APPLICATION NO.	FILING DATE	FIRST NAMED INVENTOR	ATTORNEY DOCKET NO.	CONFIRMATION NO.
10/825,690	04/16/2004	Mitsugi Chonan	032405R172	8856
441 7590 03/23/2007 SMITH, GAMBRELL & RUSSELL 1850 M STREET, N.W., SUITE 800 WASHINGTON, DC 20036			EXAMINER PILKINGTON, JAMES	
			ART UNIT	PAPER NUMBER
			3682	
SHORTENED STATUTORY PERIOD OF RESPONSE		MAIL DATE	DELIVERY MODE	
3 MONTHS		03/23/2007	PAPER

Office Action Summary

DETAILED ACTION

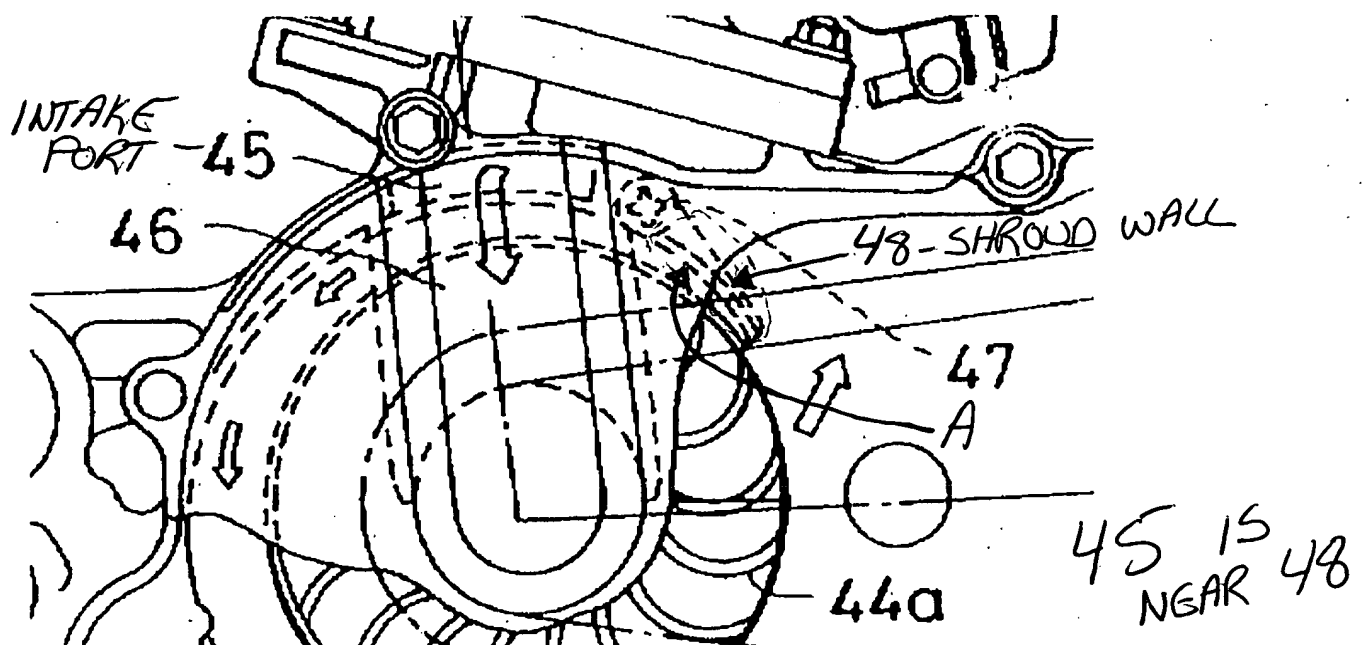
Re clm 1-8, 10-12 and 14-20, Ikenoya discloses a continuously variable transmission comprising:

- A primary pulley (8)
- A secondary pulley (10)
- A drive belt (11)
- A fan blade (44)
- A case (Figures 2 and 3)
- A shroud wall (48) arranged independently from an inner surface of the casing, and the shroud wall has a base (where attached with screw 47) and free end (where it is unattached) and near the intake region (45)

- A scrolling surface (inside surface of casing)
- A clearance gradually increasing over a quarter of said one of the pulleys (see Figure 2, pulley 16)

- wherein said shroud wall and case represent a combination that is monolithic (combined together into one part)
- wherein an interior surface of said case extends to opposite sides of said shroud wall so as to have said shroud wall increase an amount of scroll surface conformance to a rotation travel path of an outer surface of said one of the pulleys (see Figure 2)

- wherein said shroud wall has a curvature which follows along a region of said one of the pulleys (8) which region includes a first sub-region where in said pulley is in contact with the belt (shroud wall to the left of intersection point with belt) and a second sub-region wherein said pulley is free of contact with said belt (where shroud wall intersects with belt in Figure 2).

5. The applicant argues that Ikenoya fails to disclose that the intake port is arranged near the shroud wall (remarks page 6 lines 19-21, page 8 lines 10-20).

The examiner disagrees and directs the applicant to Figure 2 where it is clear that the shroud wall, defined now as character 48, is near the intake port 45. As no reference character is present in Figure 2 for the shroud wall see the Figure below.

6. The applicant argues that Ikenoya fails to disclose a shroud wall on which is formed a scrolling surface (remarks page 8 lines 1-3).

The examiner disagrees and argues that Ikenoya discloses a wall 48 on which a scroll surface is formed (surface labeled in the Figure above as A). As broadly recited claim 1 does not set forth any structural limitations that differentiate the wall and scroll surface of Ikenoya from the instant application. Ikenoya does indeed disclose that 48 is the foot portion of a plate however, a plate is indeed a wall as it has a thickness and any surface of a wall is indeed a scroll surface.
